**JOINT REGIONAL PLANNING PANEL
(Hunter & Central Coast Region)**

JRPP No	2012HCC022
DA Number	DA/1058/2012
Local Government Area	Lake Macquarie City Council
Proposed Development	147 Bed Residential Care Facility, 43 Self Care Apartments, Basement Car Park and Community Facility
Street Address	152, 154, 156, 158, 160 & 162 Brighton Avenue, TORONTO 18 Warhurst Avenue, TORONTO 245, 247 & 249 Excelsior Parade, TORONTO 201 Cary Street, TORONTO
Applicant/Owner	Anglican Care
Number of Submissions	7
Recommendation	Deferred for the applicant to respond to the issues identified in Appendix 4 to this report
Report by	Brian Gibson, Senior Development Planner

Assessment Report and Recommendation

Figure 15 – Obstructions to Ambulance manoeuvrability

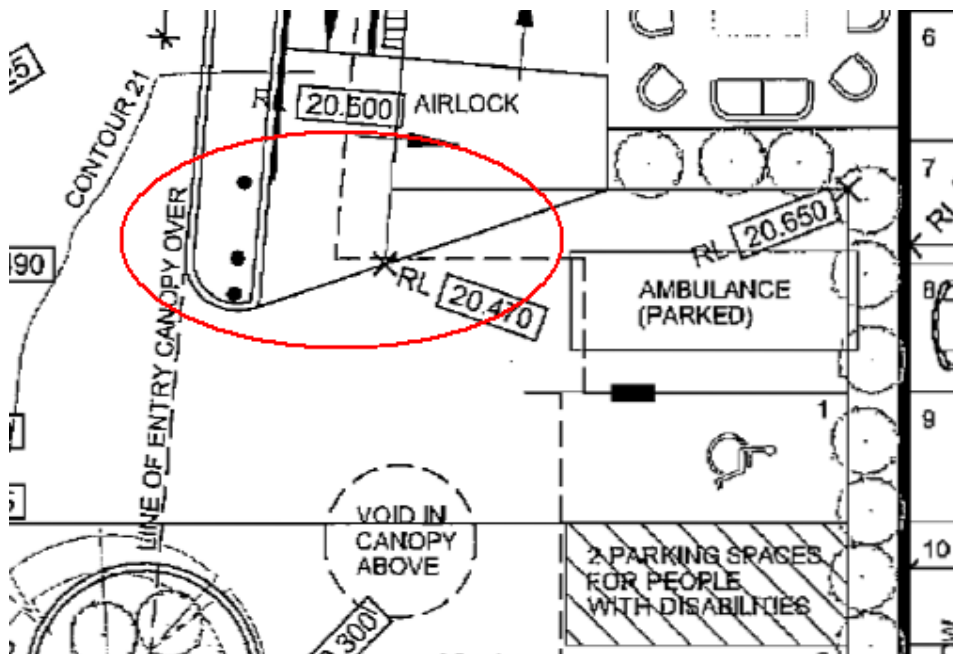
1. Ensure the sight lines from the car park access at the property boundary meets the 2.0 x 2.5 metre sight requirement as set out in AS2890.1, Figure 3.3. It is noted that it is provided on the western most driveway, the middle driveway appears as if there is no obstruction, however the substation west of the eastern driveway may cause vision obstruction if the vehicle exits the driveway close to the substation. This driveway is very wide and can be narrowed towards the central median between this 'in' and 'out'. Council DCP states that for this type of facility the driveway can be as narrow as 3 metres for each travel direction.
2. The ambulance bay appears to have a path and poles / bollards behind it which will affect manoeuvrability. Additional comment is required regarding this obstruction.

- Car Parking Areas and Structures
 - Demonstrate the sight lines from the car park access at the property boundary meets the 2.0 x 2.5 metre sight requirement as set out in AS2890.1, Figure 3.3.
